DATE: July 11, 2008
TO: Interested Parties
FROM: Joan A. Kugler, Senior Environmental Planner
RE: CASE NO. 96.281E: CENTRAL SUBWAY PROJECT (PHASE 2 OF THE THIRD STREET LIGHT RAIL PROJECT) COMMENTS AND RESPONSES

**RESPONSE TO COMMENTS
VOLUME II**

RESPONSE TO COMMENTS
VOLUME II
**FINAL SUPPLEMENTAL ENVIRONMENTAL IMPACT STATEMENT/
SUPPLEMENTAL ENVIRONMENTAL IMPACT REPORT**

FIGURE 2-16

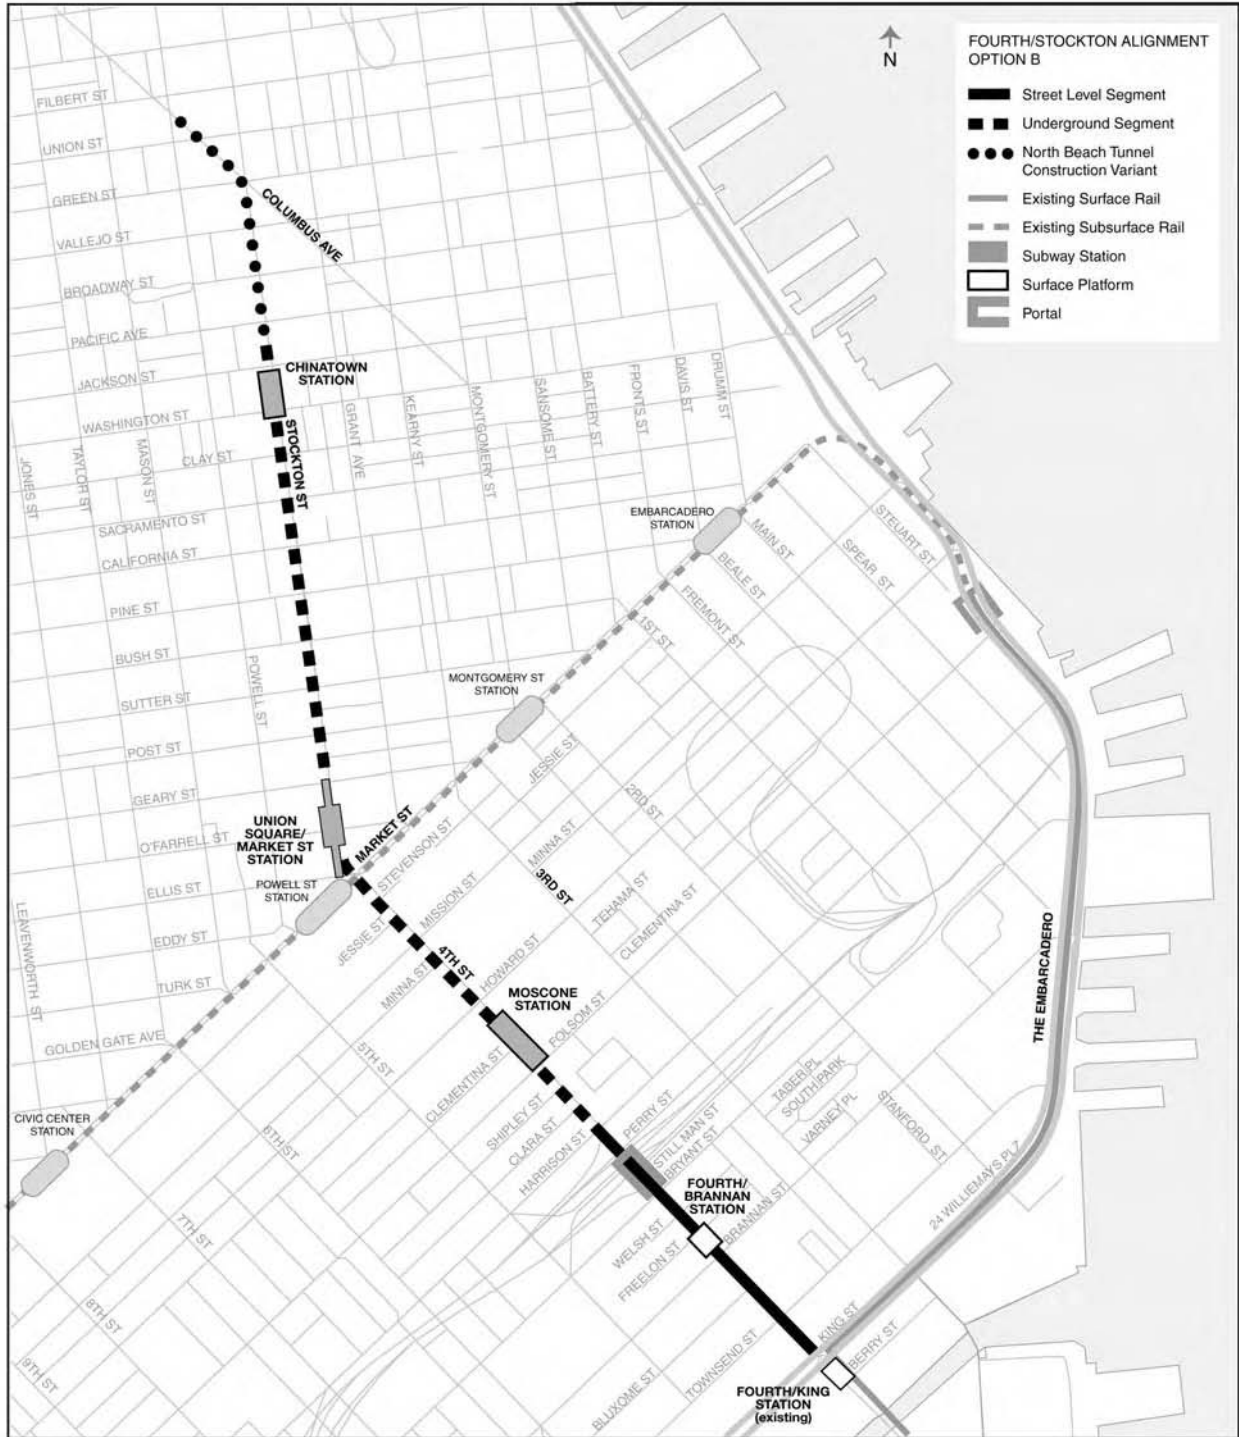
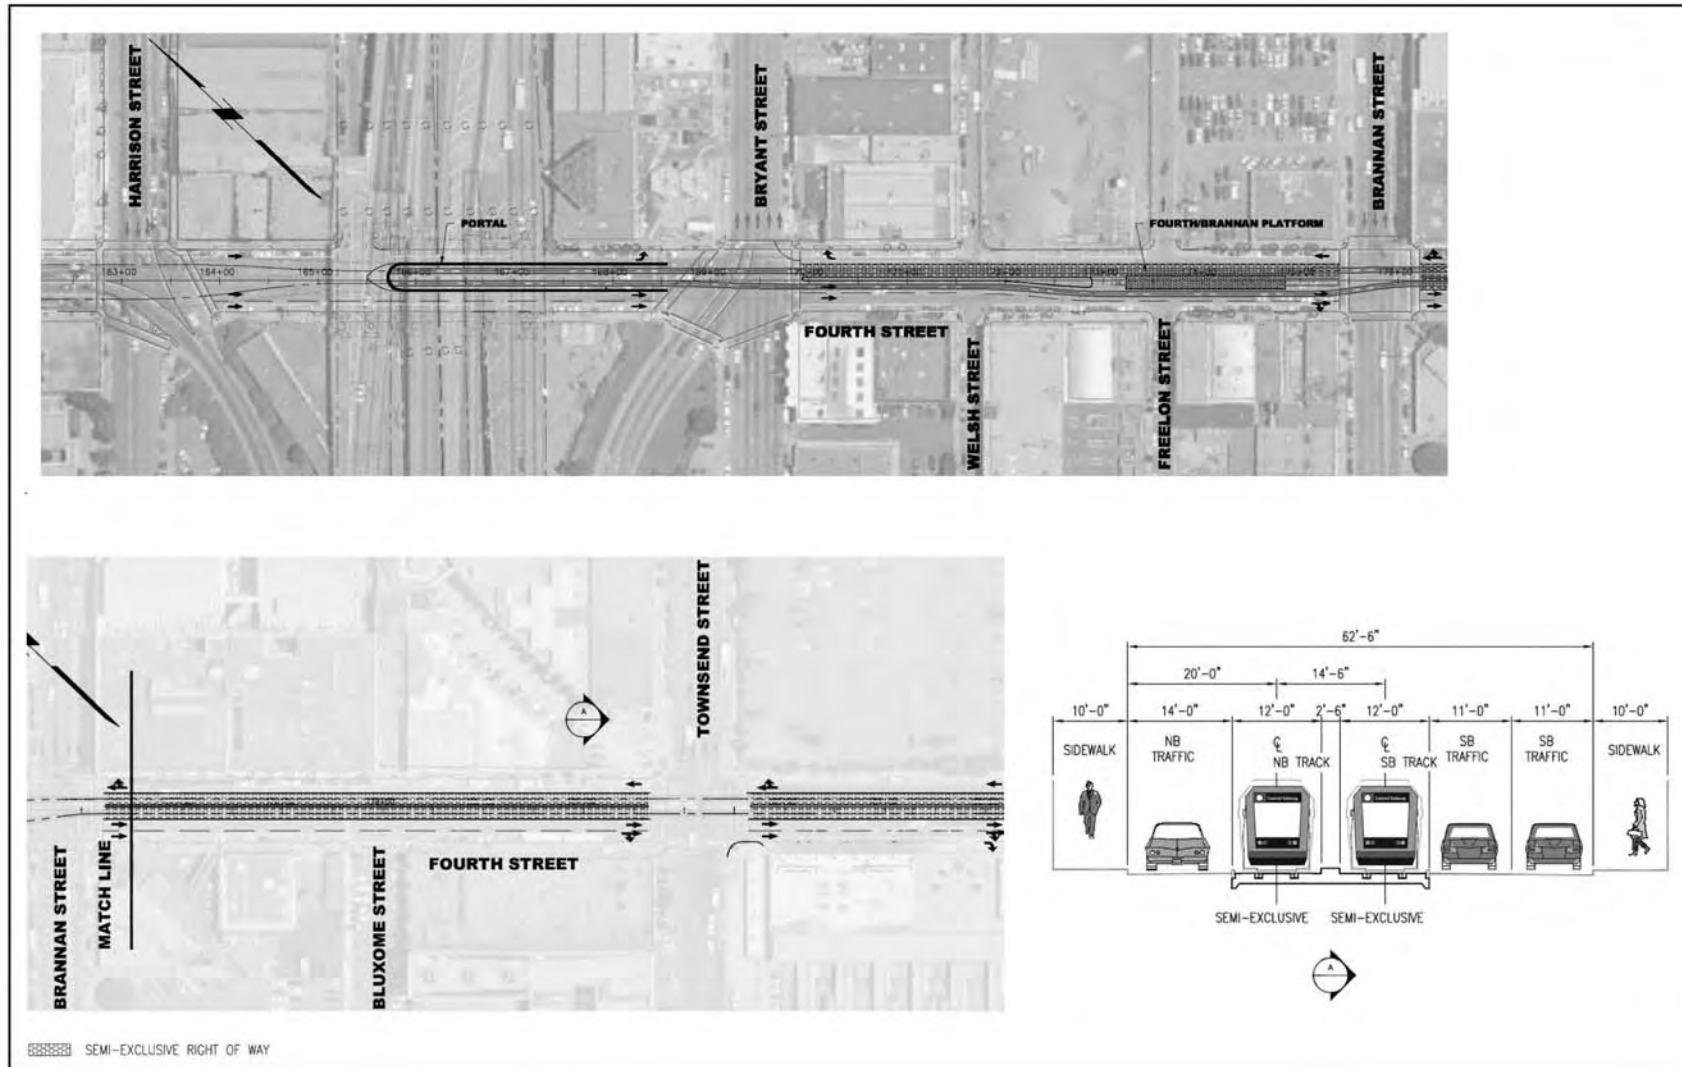
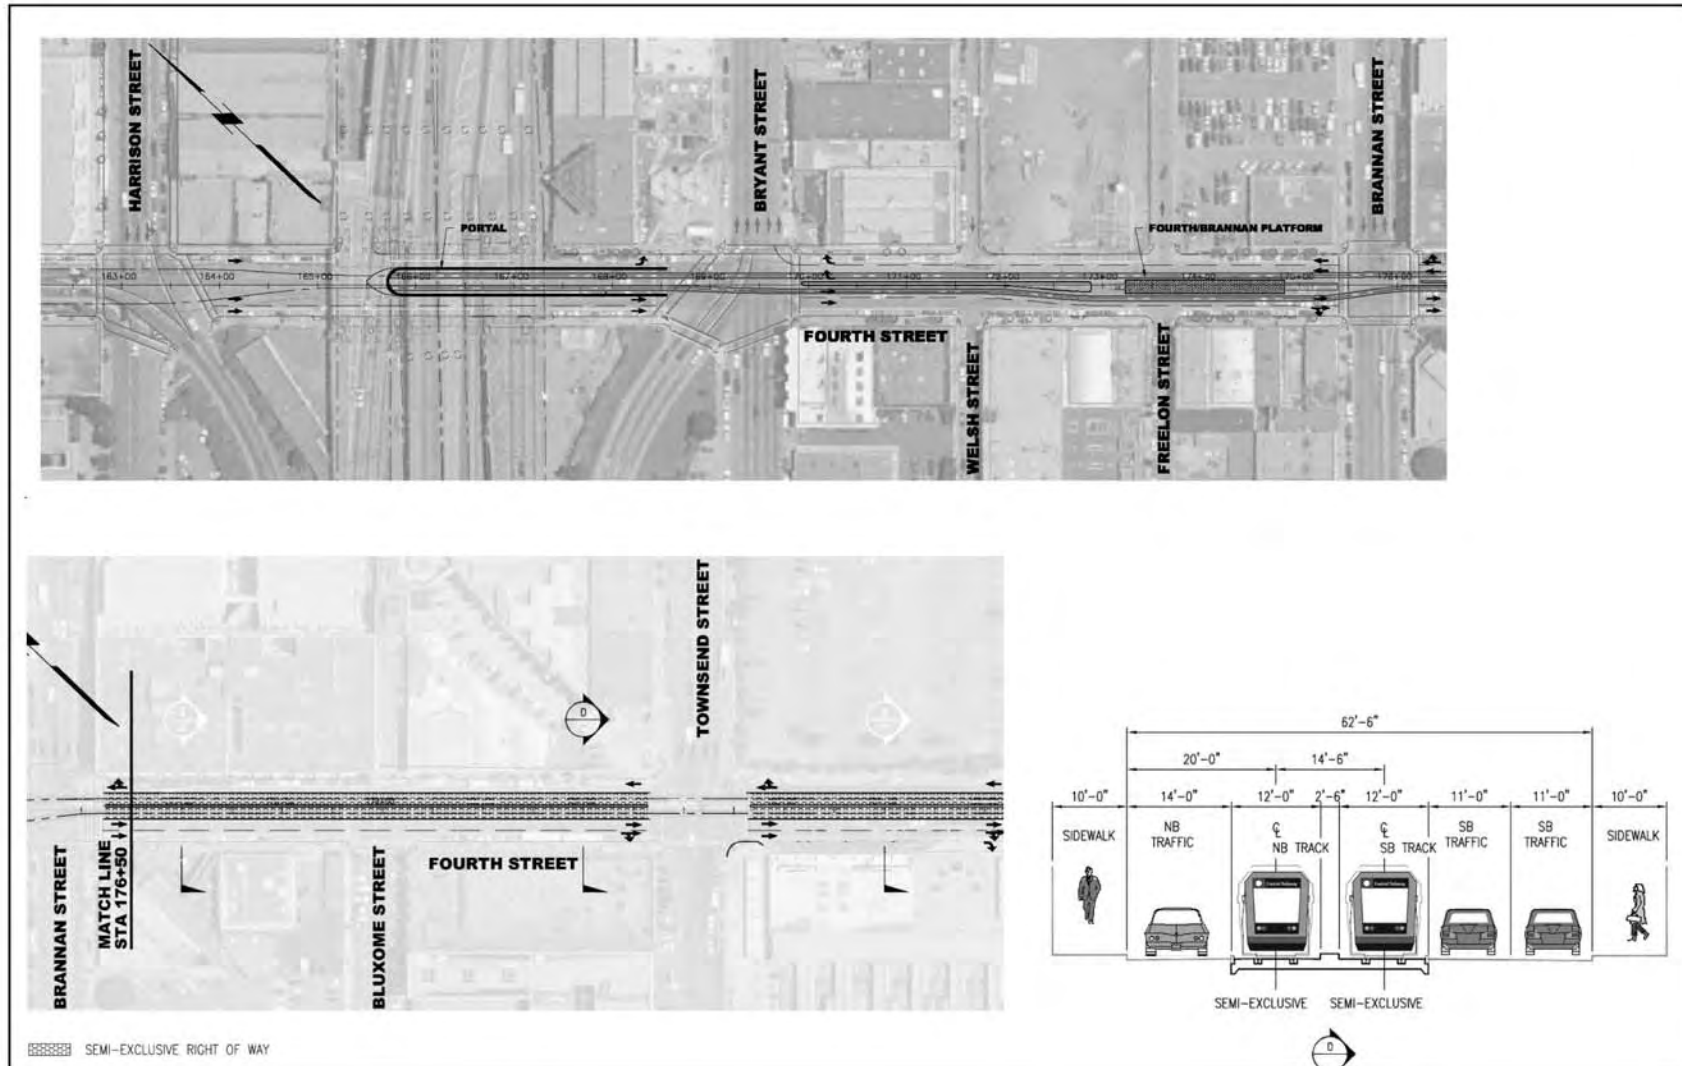
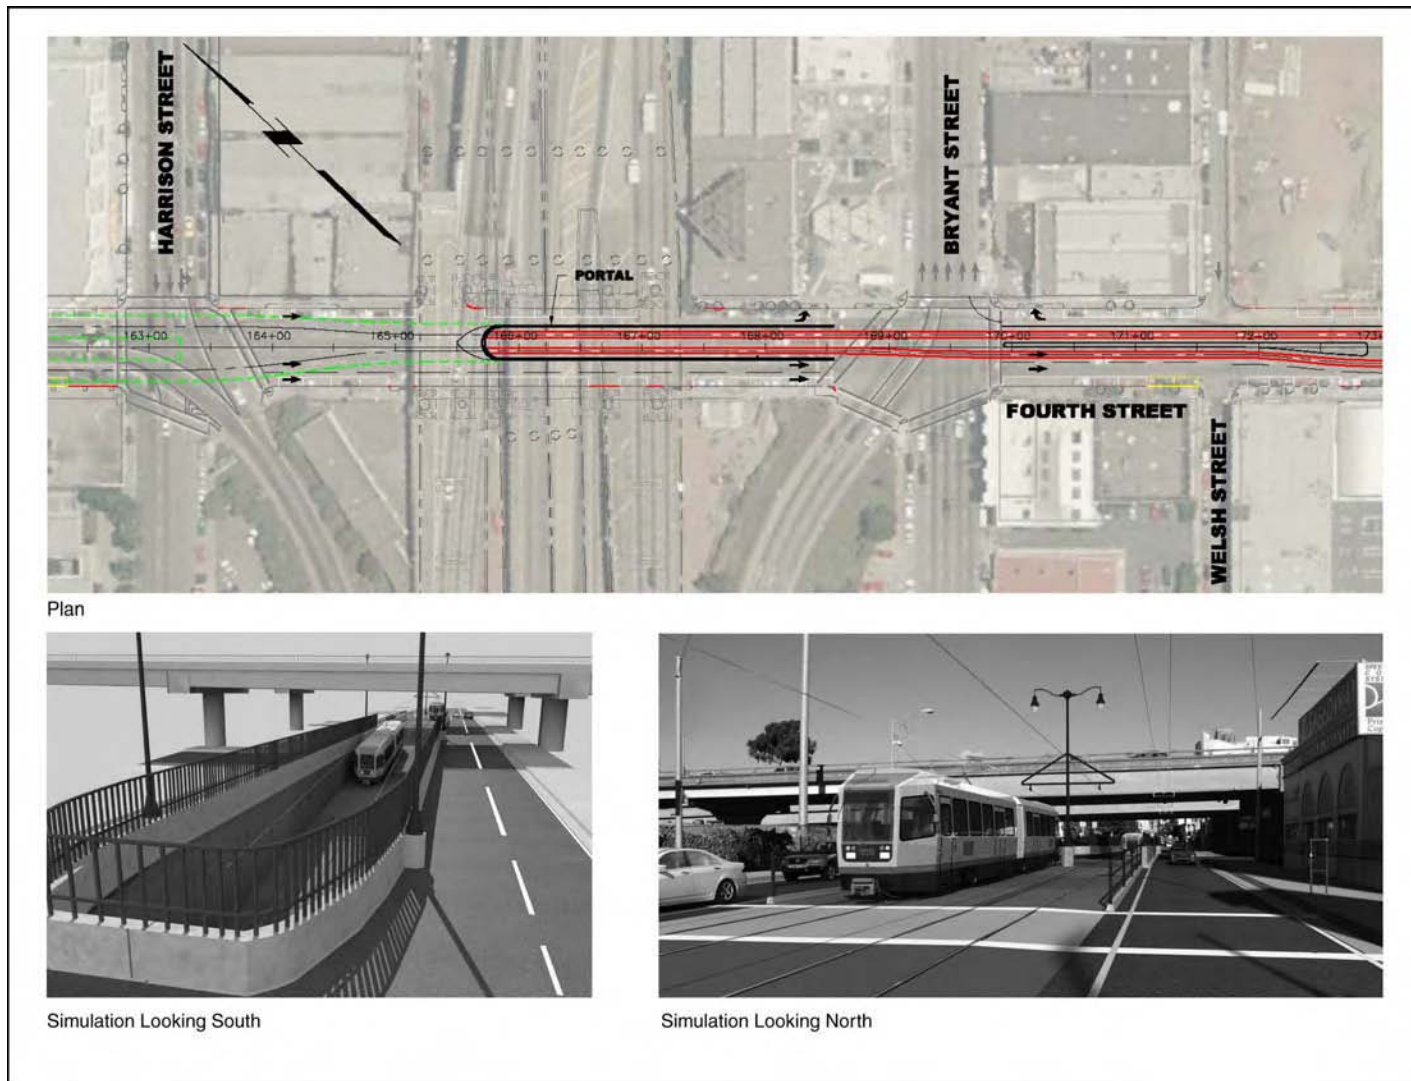
Our current schedule anticipates that the area east of Fourth Street between Perry and Stillman will be improved during and put into service prior to completion of the Central Subway construction activities on Fourth Street under the I-80 viaduct. Traffic impacts generated by construction in this area could affect bus movements and the operation of the T.J.P.A. Bus Storage facility. Specific mitigation measures that would allow buses to access the bus storage area during construction should be identified and described separately from other mitigations that propose traffic detours to avoid construction impacts unless these measures would also accommodate bus movements into and out of the bus storage area.

A crash barrier is planned for the portal to protect the entrance structure from turning buses. The current tunnel portal layout plans provide space for the tunnel crash barrier without interfering with the turning path of the bus as it enters the bus storage facility. Figure 2-18 on page 2-39, Figure 2-19 on page 2-41, and Figure 5-10 on page 5-40 have been revised to show the tunnel crash barrier. See Response to Comment R-1 for revised figures.

“After stopping at the station platform on Fourth at King Streets, light rail would continue north on Fourth Street to a double-track portal between ~~Bryant Perry~~ and Harrison Streets under I-80 (see Figure 2-16).”

Figures 2-16, 2-18, 2-19 and 5-10 are revised as noted in the attached pages to reflect the relocation of the subway portal and the placement of a crash barrier.

Figure 4-4

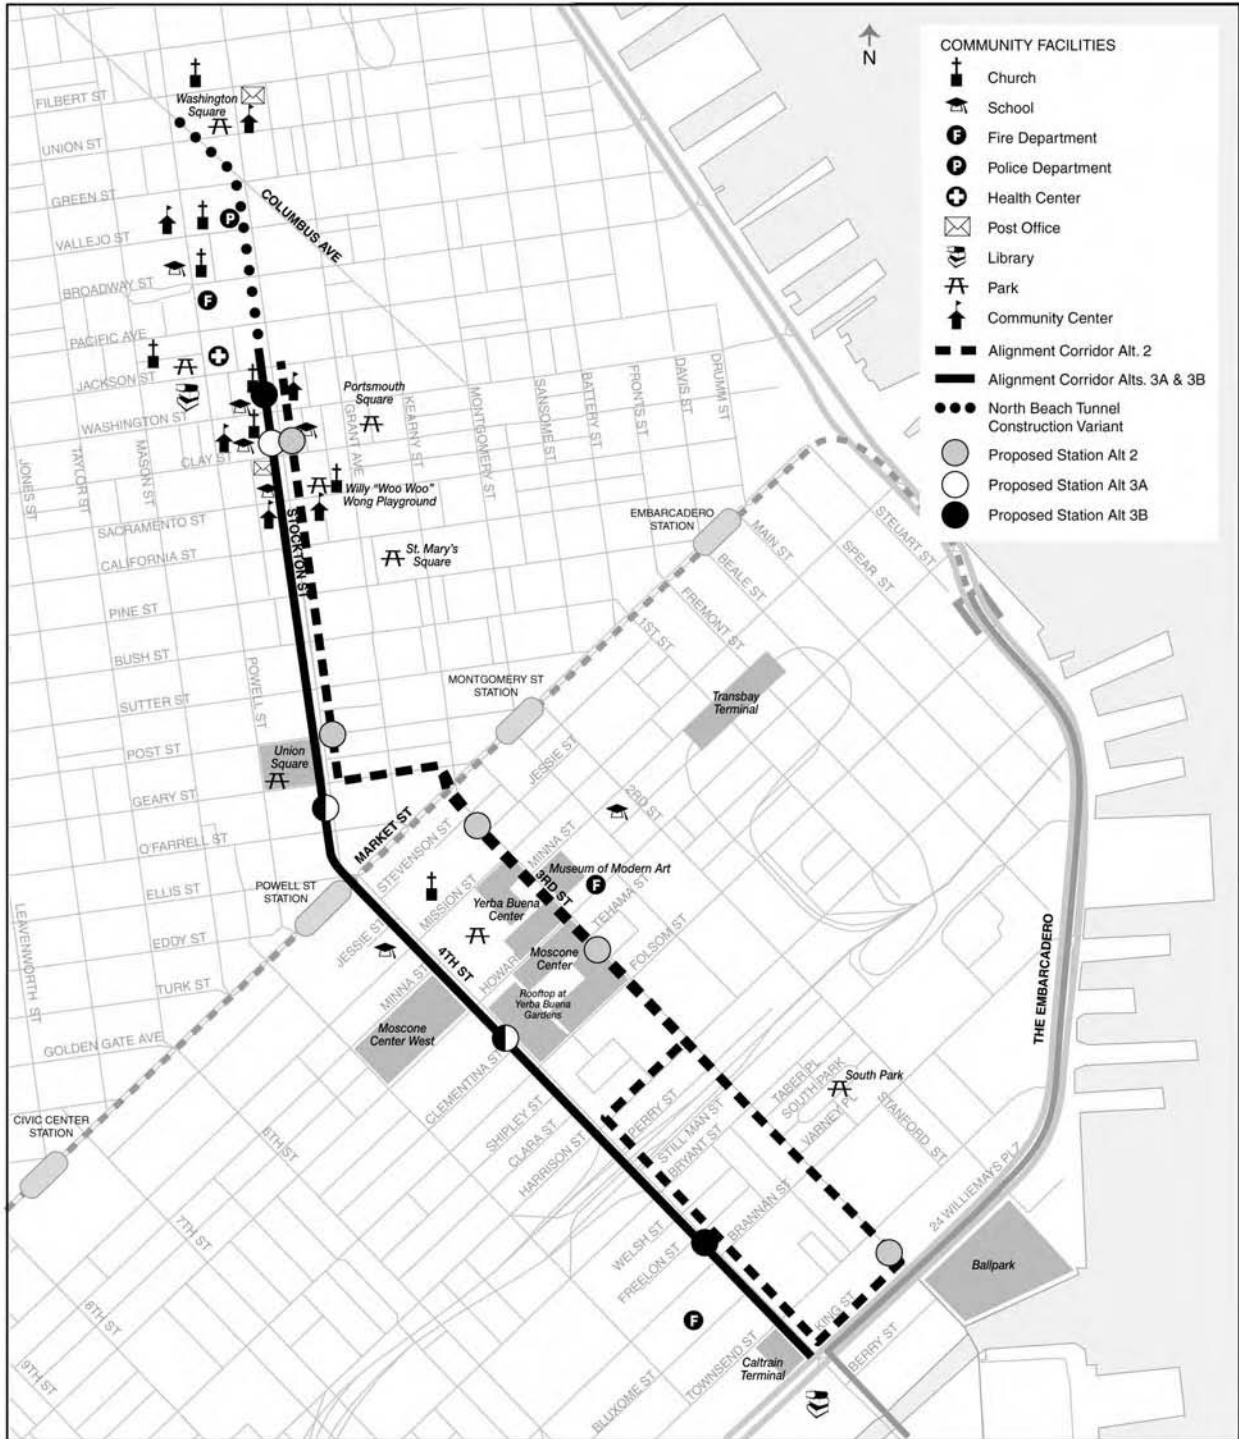
Chinese Hospital	845 Jackson	Private	Medical services
Cumberland Presbyterian Chinese Church	865 Jackson	Private	Presbyterian church
Station 2	1340 Powell	City	Fire house
Gordon Lau Elementary School	950 Clay	SF Unified School District	Elementary School
Salvation Army Chinatown Corps	1450 Powell	Private	Sunday school, senior center, community center
Central Police Station	766 Vallejo	City	Police station
Cathay Post #384 American Legion	1524 Powell	Private	Veterans association
Pin Yuen Senior Recreation Center	799 Pacific	Private	Senior center
San Francisco Chinese Baptist Church	1524 Powell	Private	Baptist church
Chinese United Methodist Church	1009 Stockton	Private	Methodist church

Figure 4-4 on page 4-36 is amended to include the Chinese Historical Society, Donaldina Cameron House, Chinatown YMCA, First Chinese Baptist Church, and Presbyterian Church in Chinatown.
